SUBJECT: Calvert Cliffs Nuclear Power Plant
Unit Nos. 1 & 2; Docket Nos. 50-317 & 50-318
Response to Request for Additional Information; Summary Report on the
Verification of Seismic Adequacy of Mechanical and Electrical Equipment in
Operating Reactors (TAC Nos. M69435 & M69436)

RESPONSE TO REQUEST FOR ADDITIONAL INFORMATION;
SUMMARY REPORT ON THE VERIFICATION OF SEISMIC ADEQUACY OF
MECHANICAL AND ELECTRICAL EQUIPMENT IN OPERATING REACTORS

The sketch below is from BGE Drawing 12005G-0012 (Bethlehem Steel Drawing 5274-DG12)

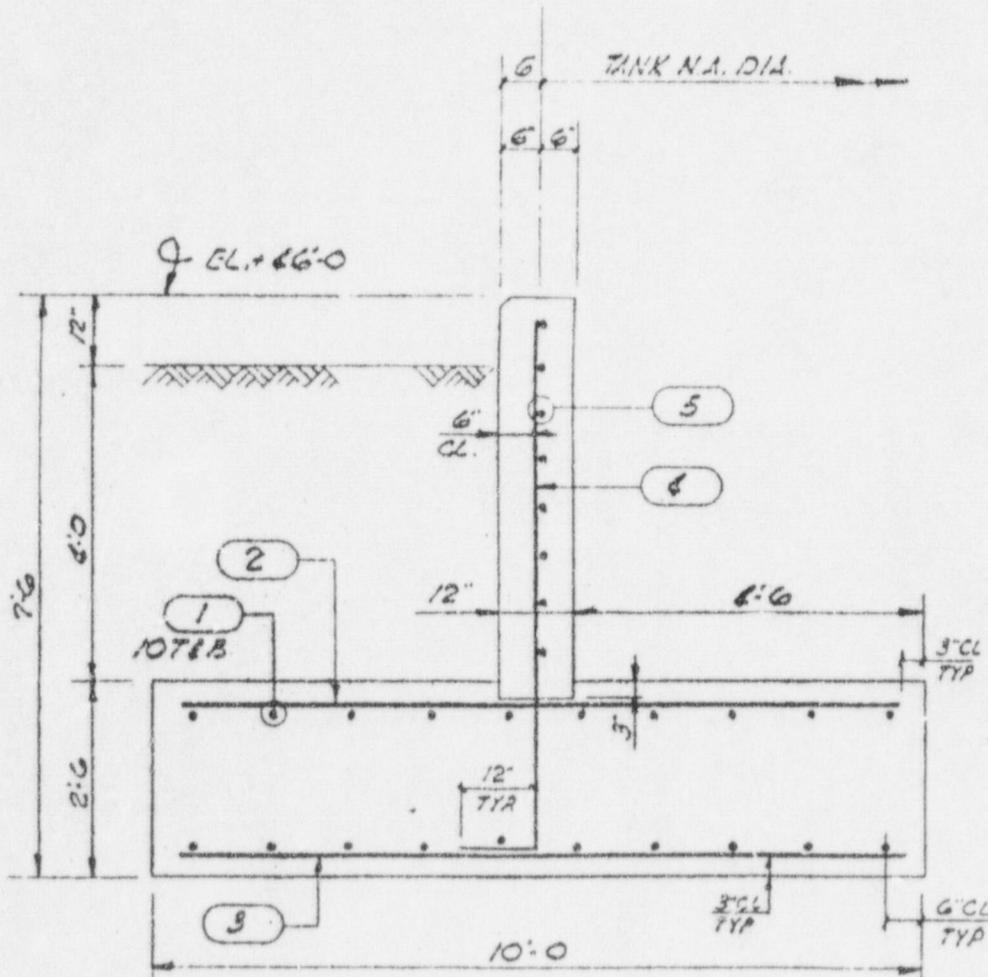
The Pretreated Water Storage Tanks (PWSTs) 0TKPWSTWG11 and 0TKPWSTWG12 were considered outliers due to "capacity versus demand" and anchorage issues. In reference to the resolution on page 25-2 of Enclosure B to your March 23, 1998 submittal [Reference (1)], you assumed that the failure mechanism was due to a failure of the bond stress between the bolt and the concrete. The staff considers that there isn't sufficient concrete in the edge and that the assumption of the concrete bond failure mode applied in this case may be unconservative. Please provide a justification.

The original seismic outliers for the PWSTs were "capacity vs. demand" and "anchorage" related. The anchorage outlier was based on the bolt edge distance and the fact that the embedment depth did not satisfy the requirements of GIP-2.

Based on the presence of a significant amount of reinforcing steel in the ring foundation the analysts concluded that failure due to an unreinforced concrete shear cone was not credible. The reinforced concrete ring is not susceptible to collapsing on itself horizontally due to the additional strength provided by the buried slab to which it is attached and its soil embedment depth. Page 25-13 of Enclosure B of the March 23, 1998 letter goes into detail on determining the "monolithic" nature of the concrete ring/slab. A sketch is attached which provides additional details on the ring foundation. This sketch represents a "section" cut of the PWST ring foundation.

The failure mechanism was, therefore, concluded to be the failure of the bond stress between the cast-in-place anchor and the concrete. The use of an ultimate bond stress of 200 psi for plain steel rod is considered acceptable per EPRI Report NP-5228-SL, Rev. 1, Volume 1.

Baltimore Gas and Electric Company believes the conclusion of seismic adequacy for the PWSTs is justified.
